# Access Compliance Report

## Public Rights-of-Way

### (Curb Ramps)

Intersection ID: 45830	Main Street: EMMA_LYNN_CT	Cross Street: CHRISTENBURY_HILLS_LN	Location: SE
ADA ID: 72914C38A2FB	Ramp Type: Perp	Initial Pass/Fail: Fail	Overall Compliance: No
Severity Score: 25			
Codes/Mitigation Info/Possible Solution		Field Measurements/Component Compliance

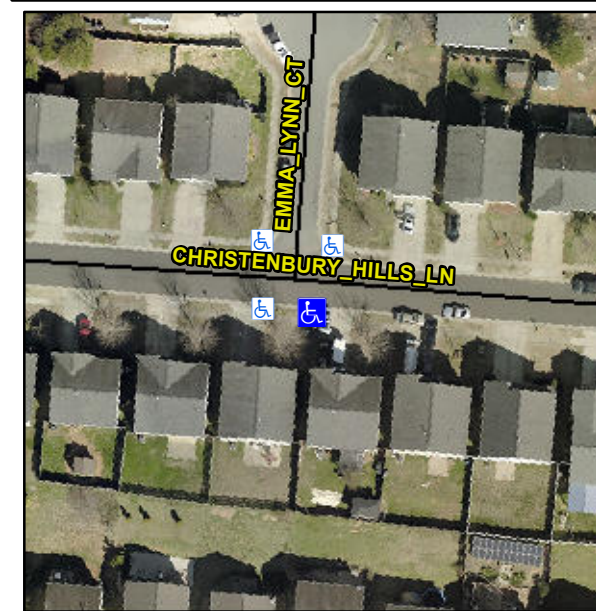
**Not Found, R304.2.2, R304.5.3**

Compliance	Description	Data	Compliance	Description	Data
N/A	Ramp Length (in)	49.0	No	Ramp Slope (%)	10.3
Yes	Ramp Width (in)	48.0	No	Ramp XSlope (%)	5.1
N/A	Flare Type LT	N/A	N/A	Flare Type RT	N/A
N/A	Flare Slope LT (%)	N/A	N/A	Flare Slope RT (%)	N/A
N/A	Flare Traversable LT?	N/A	N/A	Flare Traversable RT?	N/A
N/A	Landing Length (in)	N/A	N/A	DWS Provided?	N/A
N/A	Landing Width (in)	N/A	N/A	DWS Contrast?	N/A
N/A	Landing Slope (%)	N/A	N/A	DWS Length (in)	N/A
N/A	Landing X Slope (%)	N/A	N/A	DWS Full Width?	N/A
N/A	Landing Curb? (Y/N)	N/A	N/A	DWS Offset (in)	N/A
N/A	Shared Landing?	N/A			
N/A	Gutter Ponding?	N/A	N/A	Gutter Slope (%)	N/A
N/A	Gutter Lip Ht (in)	N/A	N/A	Gutter X Slope (%)	N/A
N/A	Painted X Walk1?	No	N/A	Painted X Walk2?	N/A
	X Walk 1 Direction	To N		X Walk 2 Direction	N/A
N/A	X Walk 1 Width (in)	N/A	N/A	X Walk 2 Width (in)	N/A
	X Walk 1 Slope (%)	4.3		X Walk 2 Slope (%)	N/A
	X Walk 1 X Slope (%)	5.1		X Walk 2 X Slope (%)	N/A

**Remove & Replace Entire Ramp.**
